Access Compliance Report Public Rights-of-Way (Curb Ramps)

Intersection ID: 20285 Main Street: BELKNAP_RD Cross Street: CORTELYOU_RD Location: SW

ADA ID: 2A527946D48F Ramp Type: PerpDiag Initial Pass/Fail: Fail Overall Compliance: No Severity Score: 21.25

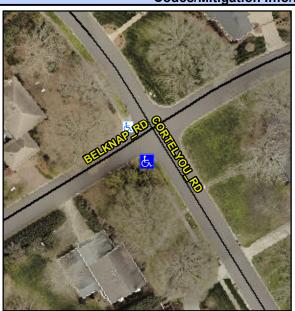
Remove & Replace Curb Ramp With Two New Directional Ramps or Equivalent.

Not Found, R304.5.1, R304.2.2

Field Measurements/Component Compliance						
	Compliance Description		Data	Comp	oliance Description	Data
	N/A	Ramp Length (in)	70.0	No	Ramp Slope (%)	9.1
	No	Ramp Width (in)	45.5	Yes	Ramp XSlope (%)	0.4
	N/A	Flare Type LT	N/A	N/A	Flare Type RT	N/A
	N/A	Flare Slope LT (%)	N/A	N/A	Flare Slope RT (%)	N/A
	N/A	Flare Traversable LT?	N/A	N/A	Flare Traversable RT?	N/A
	N/A	Landing Length (in)	N/A	N/A	DWS Provided?	N/A
	N/A	Landing Width (in)	N/A	N/A	DWS Contrast?	N/A
	N/A	Landing Slope (%)	N/A	N/A	DWS Length (in)	N/A
	N/A	Landing X Slope (%)	N/A	N/A	DWS Full Width?	N/A
	N/A	Landing Curb? (Y/N)	N/A	N/A	DWS Offset (in)	N/A
	N/A	Shared Landing?	N/A			
	N/A	Gutter Ponding?	N/A	N/A	Gutter Slope (%)	N/A
	N/A	Gutter Lip Ht (in)	N/A	N/A	Gutter X Slope (%)	N/A
	N/A	Painted X Walk1?	No	N/A	Painted X Walk2?	No
		X Walk 1 Direction	To NE		X Walk 2 Direction	To NW
	N/A	X Walk 1 Width (in)	N/A	N/A	X Walk 2 Width (in)	N/A
		X Walk 1 Slope (%)	1.2		X Walk 2 Slope (%)	5.7
